northern
beaches
council

DEVELOPMENT DETERMINATION PANEL MEETING

WEDNESDAY 23 FEBRUARY 2022

ITEM 3.1	DA2021/2067 - ATTUNGA ROAD NEWPORT - ALTERATIONS AND ADDITIONS TO A DWELLING HOUSE INCLUDING A CARPORT
REPORTING MANAGER	TONY COLLIER
TRIM FILE REF	2022/090680
ATTACHMENTS	1 ↓ Assessment Report 2 ↓ Site Plans and Elevations 3 ↓ Clause 4.6

Figure 1: Building height non-compliance. Existing non-compliance highlighted in green; proposed additional non-compliance in red

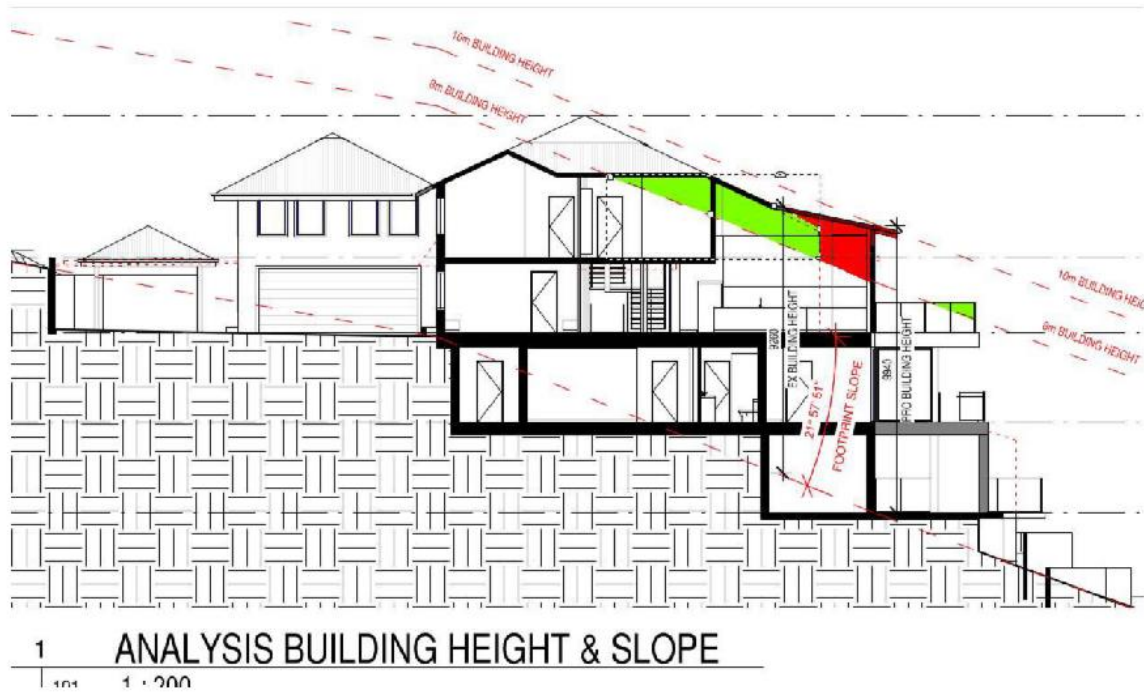
The site is subject to an 8.0m maximum building height under the requirements of Clause 4.3 of Pittwater LEP 2014. The proposed development contains a maximum building height of 9.94m, which represents a 24.25% variation from the Development Standard.

Figure 1 below demonstrates the area of the development that exceeds the 8.0m statutory height limit (existing non-compliance highlighted in green; proposed additional non-compliance in red).

Figure 3: Building height non-compliance of proposed works shown in green (South Elevation)

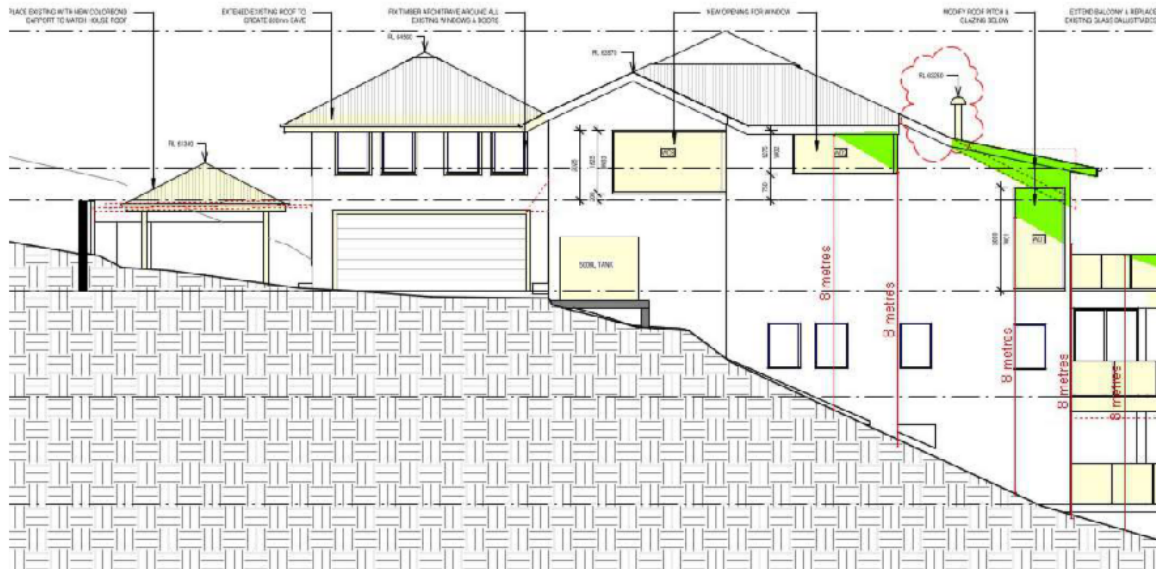
Figure 2: Building height non-compliance of proposed works shown in green (North Elevation)

Fig 1: Extract of proposed roof area which demonstrates extent of variation to statutory height limit when assessed against a natural ground line through the site, in its undisturbed state

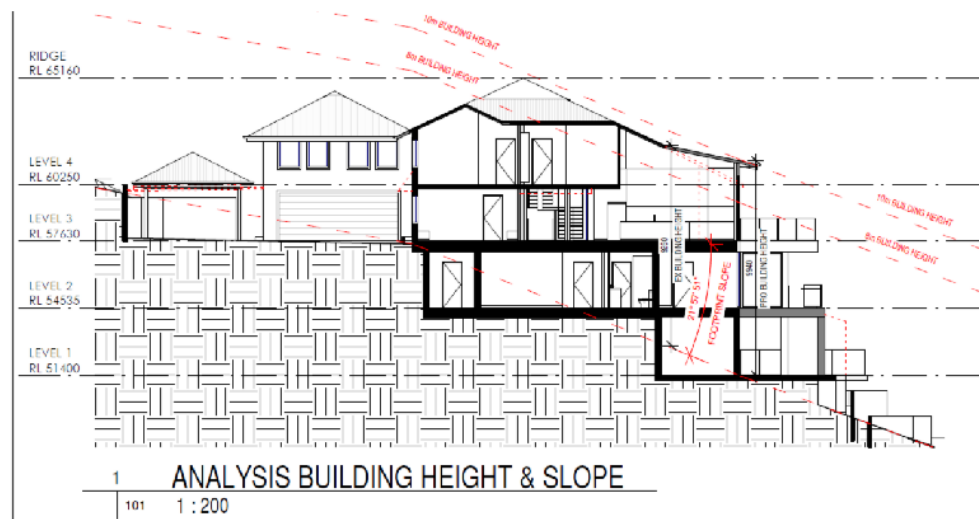
The figure below notes the variation to the maximum height control occurs as a direct result of the site's steep & falling levels towards the northern, rear boundary.

The proposal is considered acceptable and there are sufficient environmental planning grounds to justify contravening the development standard.

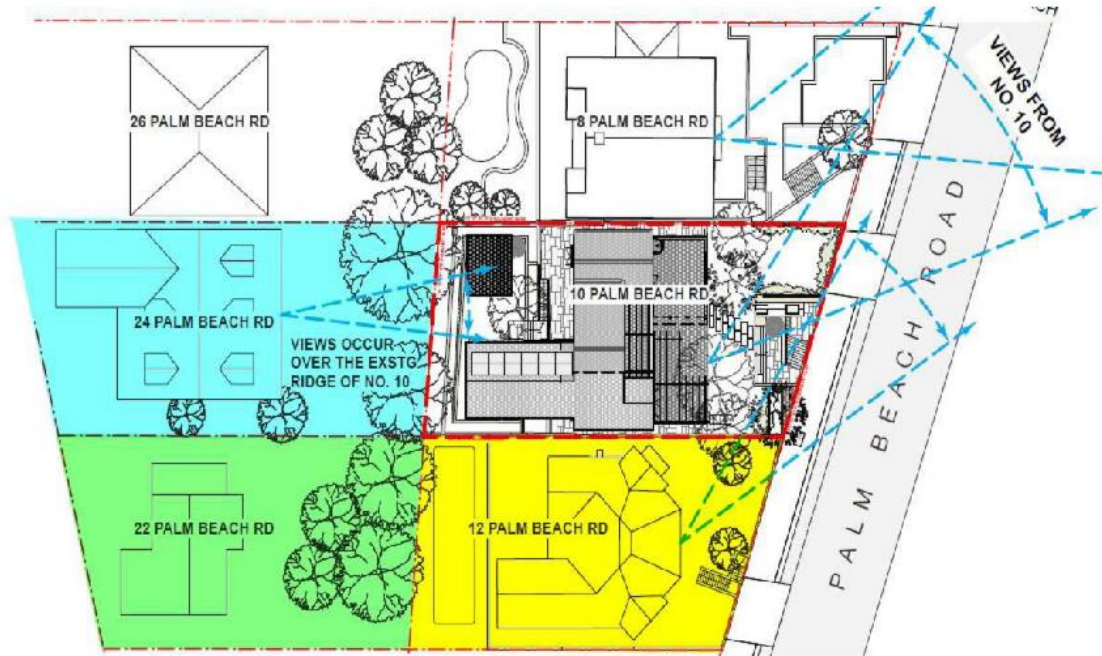
Three objections to the development application have been received and each raise view loss as a concern.

For ease of understanding the location of the objecting properties the below diagram has been prepared:

Yellow - 12 Palm Beach Road - concerned about view loss caused by a proposed banksia tree.

Photo 5. Approximate worst case impact to views from No. 71 lower level northern balcony.

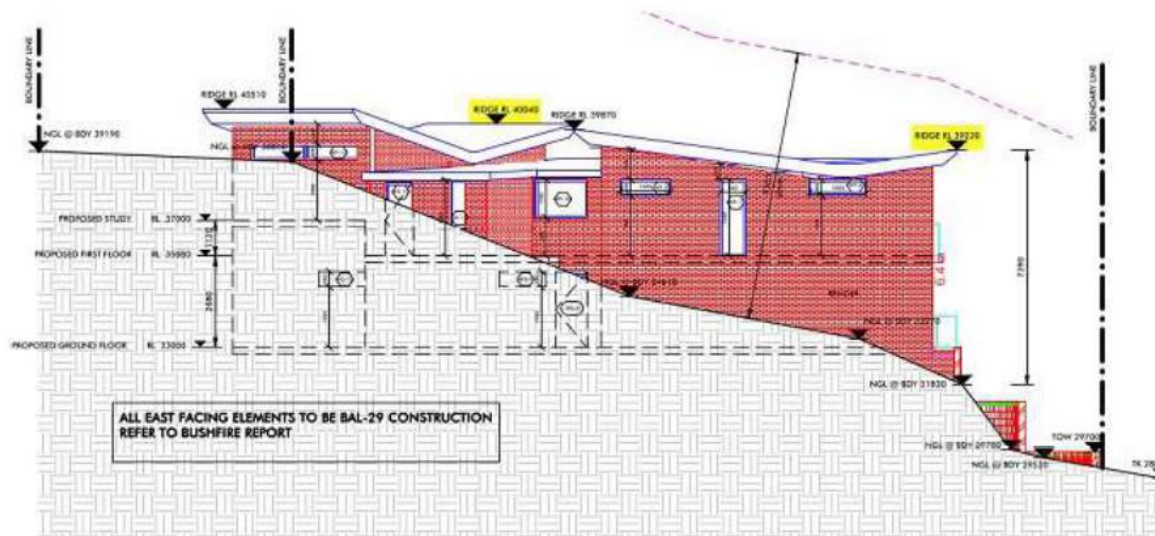
In Photo 3, the upper line represents the approximate worst case scenario based on the maximum height of the proposed roof at the leading western edge (RL 40.04). The actual extent of the impact is anticipated to be lesser as the central and northern roof sections reach a maximum height of RL 39.22 (lower line) at the leading western edge. However, even if the impact was to the extent shown by the upper line, the impact would still be acceptable.
